**CHARTER TOWNSHIP OF VAN BUREN
PLANNING COMMISSION - VIRTUAL MEETING ON ZOOM
January 27, 2021
MINUTES**

**Subject: VBT-19-001; Project Sycamore; 9000 Haggerty Road; AMENDED Site Plan Review #2;
Revised Site Plans Dated October 28, 2020.**

**Project Sycamore – 9000 Haggerty Road
Engineering and Final Site Plan Review**

Re: Amended Preliminary Site Plan
Project Sycamore
9000 Haggerty Rd
Van Buren Twp, MI 48111

Figure 1: Original approved site plan

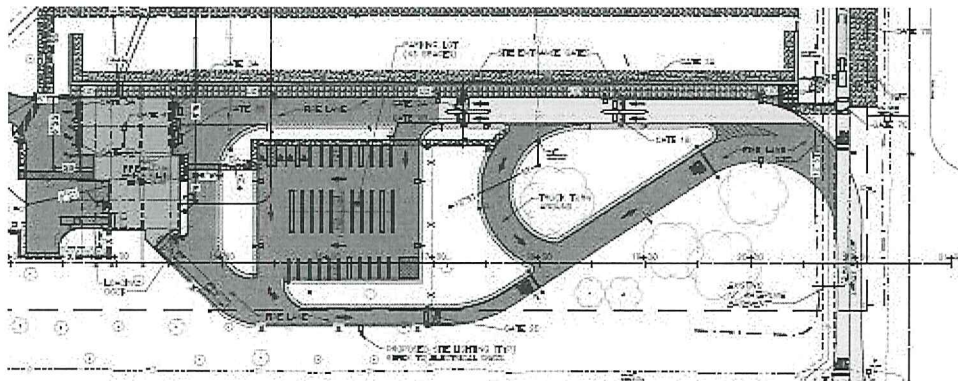
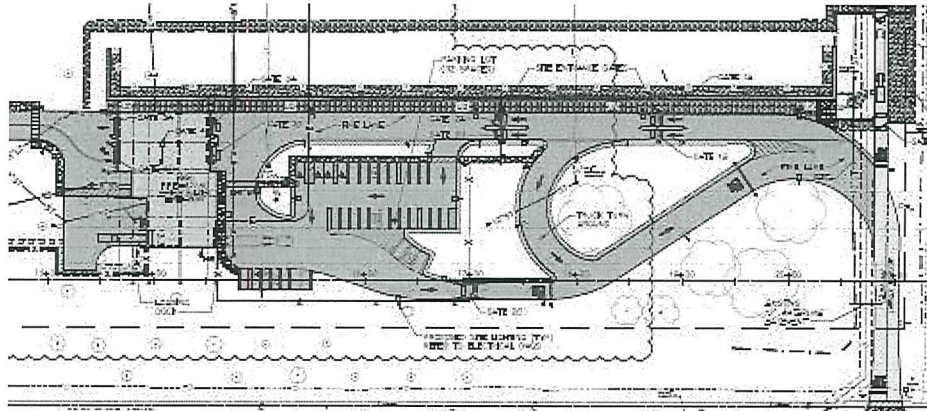
The previously approved plan (shown below – figure 1) had vehicles enter and exit the site off Haggerty and then move in a one-way direction towards the VVRC building for security check. The parking lot on the east side of the VVRC building had limited amount of parking with a one-way circulation pattern creating a loop.

The amended plan proposed (figure 2 above) eliminates the angled truck dock at the northeast corner of the VVRC building, reduces the amount of parking shown and creates a small new area of parking abutting the dock area. The circulation continues to remain in a one-way configuration forming a loop.

Figure 3: Amended site plan

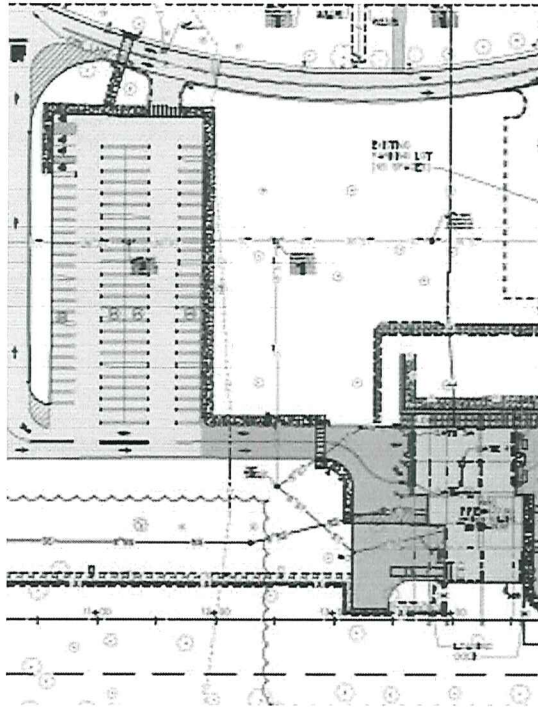
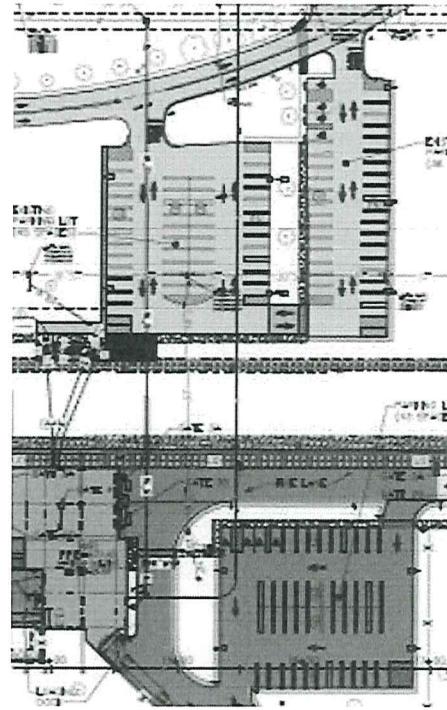
- a. **Space Dimensions.** The amended site plan proposes the creation of a new parking lot on the southwest side of the VVRC building (figure 3) and elimination of the previously proposed reconfigured existing parking lot on the northwest side of the VVRC building (figure 4). Sheets C-3003 and C-3005 provide details of the proposed parking areas. All spaces measure 9.5’ x 20’, and are double striped as required. The aisle width is 24’ as required by the Ordinance. The parking area abutting the VVRC building has appropriate pavement marking to show one way movement of vehicles.
